SERVICE BULLETIN SB-041323-A

ID NUMBER & REVISION: SB-041323-A SUBJECT: **ELT Antenna Corrosion RELEASE DATE:** 8 June 2023 **EFFECTIVE DATE:** 8 June 2023 SUPERSEDES NOTICE: N/A AIRCRAFT AFFECTED: MAKE & MODEL: ICON A5 **SERIAL NUMBERS:** 00001 - 00185 **REQUIRED ACTION:** Perform a one-time inspection of the ELT antenna to identify any corrosion and remove and replace the ELT assembly as necessary. TIME OF COMPLIANCE: One time inspection, at the next service interval. **REVISION HISTORY:** Initial Release Α Pilot/Owner A & P \square \boxtimes LEVEL OF CERTIFICATION □ LSA Repairman – Inspection \times Certified Repair Station **REQUIRED** (any level checked can perform task): ⊠ Manufacturer \times LSA Repairman – Maintenance

Figure 1 Evidence of Corrosion Underneath the Cowl

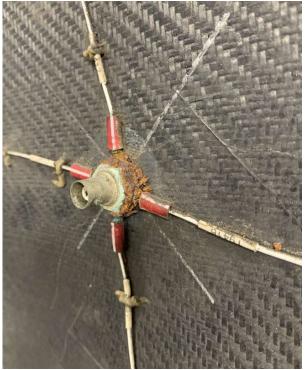
- 1. Remove the top engine cowling.
 - a. ICON Aircraft Maintenance Manual: Remove Engine Cowlings (100497).
- 2. Inspect the antenna connectors and grounding wires underneath the top cowling (non-painted side) for evidence of corrosion.
 - a. See Figure 1 for an example of corrosion.
 - b. If there is corrosion, proceed to "Repair Corrosion" section of this Service Bulletin
 - c. If there is no corrosion, proceed to "Logbook Entry".
- 3. Inspect the steel wire located on the ACK ELT Whip Antenna, on top of the cowling (painted side) for evidence of corrosion.
 - a. See Figure 2 for inspection location.
 - b. If there is corrosion, proceed to "Repair Corrosion" section of this Service Bulletin
 - c. If there is no corrosion, proceed to "Logbook Entry".

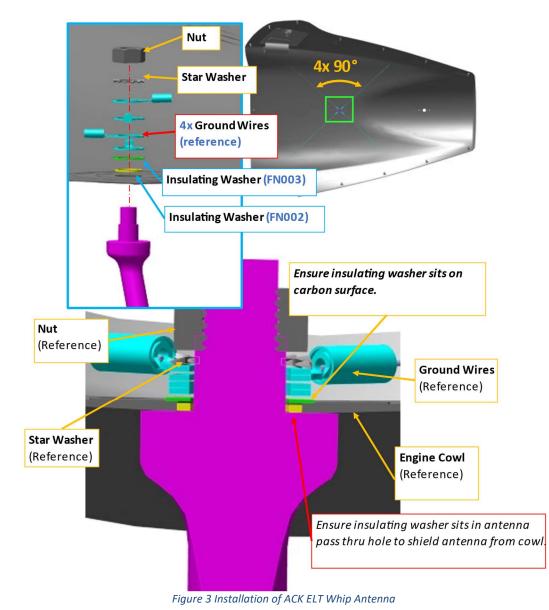
- 9. Secure the ACK ELT Antenna and ground wires:
 - a. Install insulating washers (ICA015003 (FN003) and ICA015004 (FN002)) and ELT ground wires (4 terminals) on lower unpainted side of cowl and secure using star washer and nut as shown in Figure 3.

- b. Ensure that each ring terminal is at a 90° angle from one another.
 - c. Ensure the 4x ground wires are 90° from one another as shown in Figure 3.

Figure 4 Bottom of Cowling, Bonding Locations

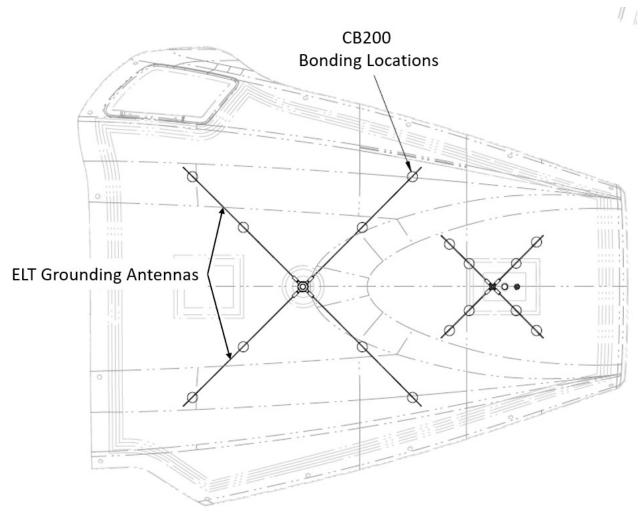
- 14. Verify all connectors have their locking features engaged.
- 15. See Figure 4 for placement of the adhesive and re-bond using CB200 at those locations.

- 16. Prepare the CB200 in accordance with the manufacturer's instructions.
 - a. Note application time, handling time, and cure time.
- 17. Apply 8x 0.50" diameter dollops of CB200 at the bonding locations.

Figure 6 ACK ELT Forward Looking Aft

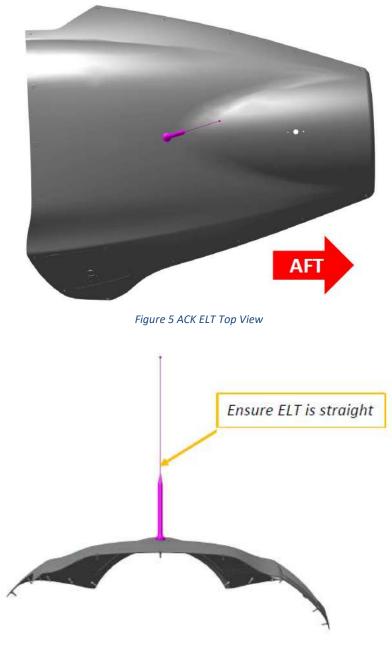
- 19. Ensure that the ACK ELT Whip Antenna is straight pointing AFT after installation.
 - a. See Figures 5, 6, and 7.
- 20. Using isopropyl alcohol, thoroughly and carefully clean the top of the ACK ELT Whip Antenna: a. See Figure 2.
- 21. Install the top engine cowling.
 - a. ICON Aircraft Maintenance Manual: Install Engine Cowlings (<u>100335</u>).
- 22. Proceed to "Logbook Entry".
